# CITY OF West Linn

### PLANNING DIRECTOR DECISION

FILE NO.: DR-12-10/WAP-12-02

REQUEST: Class I Design Review and Water Resources Area permit for a proposed stormwater detention facility at Cedaroak Primary School at 4515 Cedaroak Drive

**OVERALL SITE PLAN**

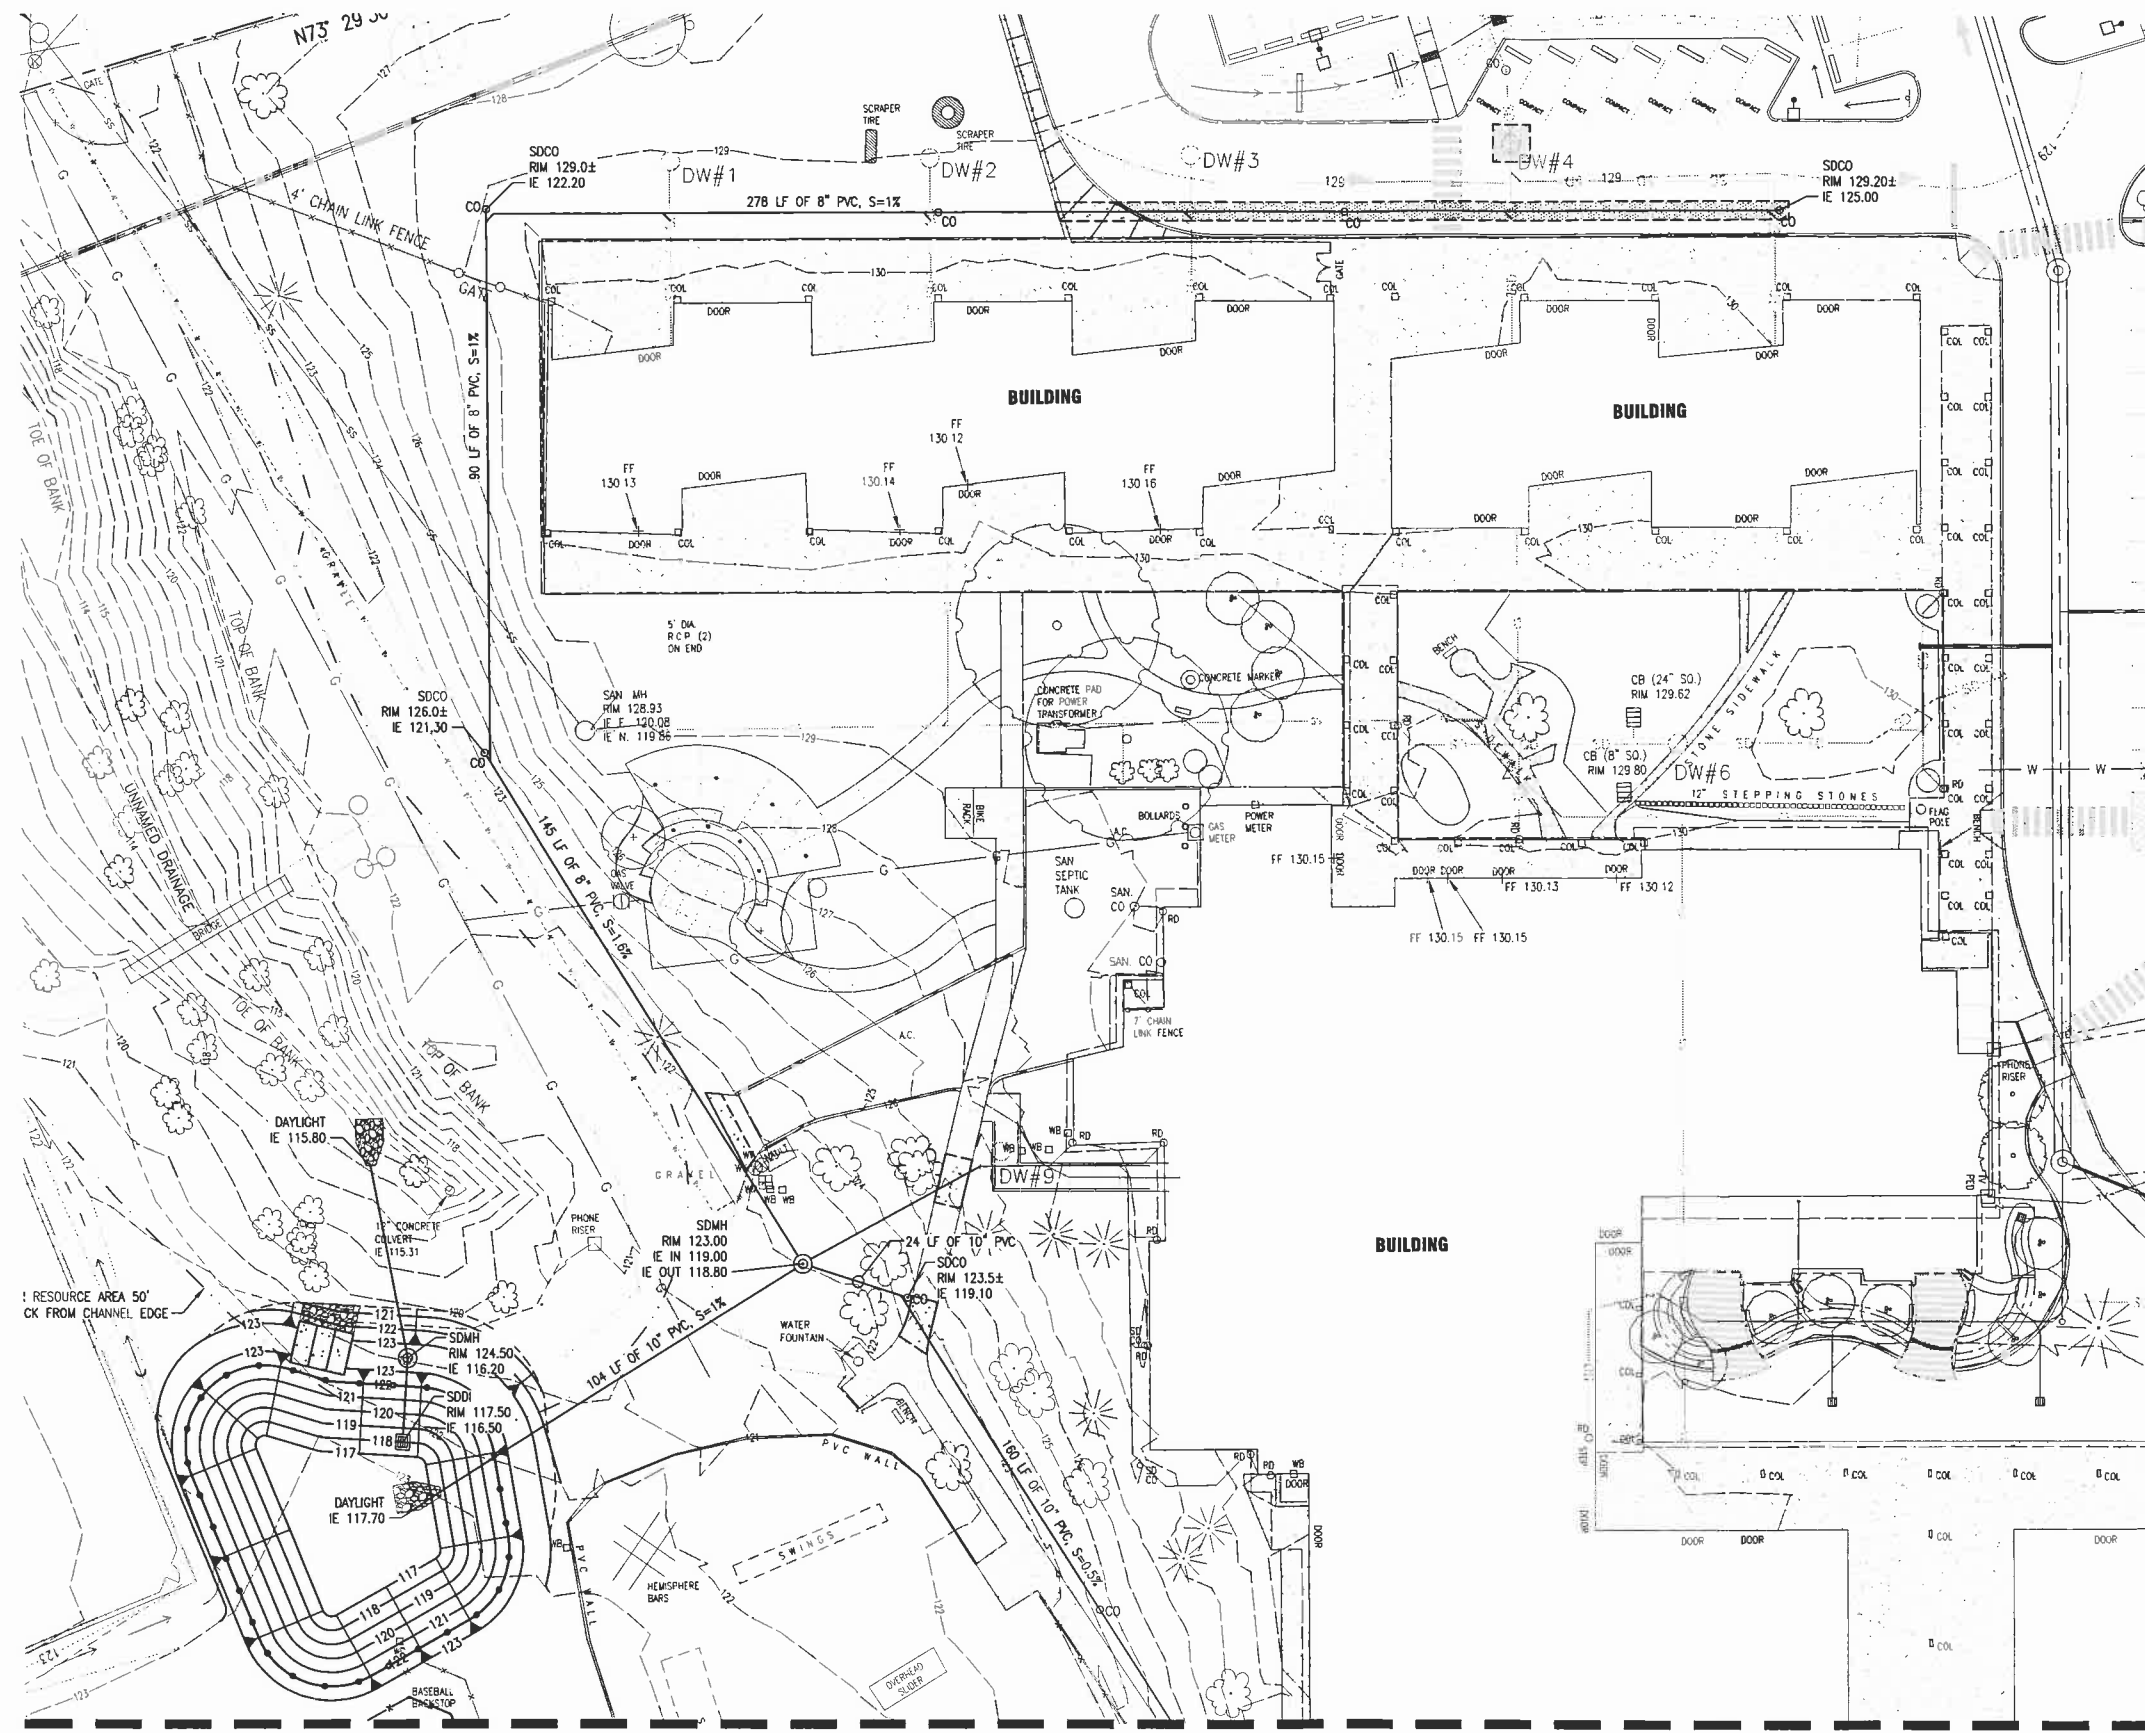
1. Tentative Plan. The improvements shall conform to the Overall Site Plan, Sheet C1.3, on Page 42 of Exhibit PD-4, the Detention Pond Plan, Sheet C3.1 dated April 13, 2012, on page 45 Exhibit PD-4, and Detention Pond Planting Plan, Sheet L1.1, on Page 47 of Exhibit PD-4, dated March 2, 2012, except as modified by these conditions of approval.

- **55.090(A)** - This criterion is now addressed in the narrative.
- **55.120(D) and 32.060(B)(3)** - The plan sheets have added an “unnamed drainage” label for the stream.
- **32.040(G)** - A table was added to Sheet C1.3 showing the ground cover percentages.
- **32.040(G)** - A table was added to Sheet C1.3 showing the ground cover percentages.
- **32.060(A)** - The name and address information is provided on the cover sheet.
- **32.060(B)(2)** - Shading of the 25% slope areas is provided on Sheet C1.3.
- **32.060(B)(6)** - A general description of the site vegetation is provided on Sheet C1.3.
- **32.070(B)** - The proposed fee-in-lieu arrangement proposed in coordination with parks is described in more detail in the narrative.
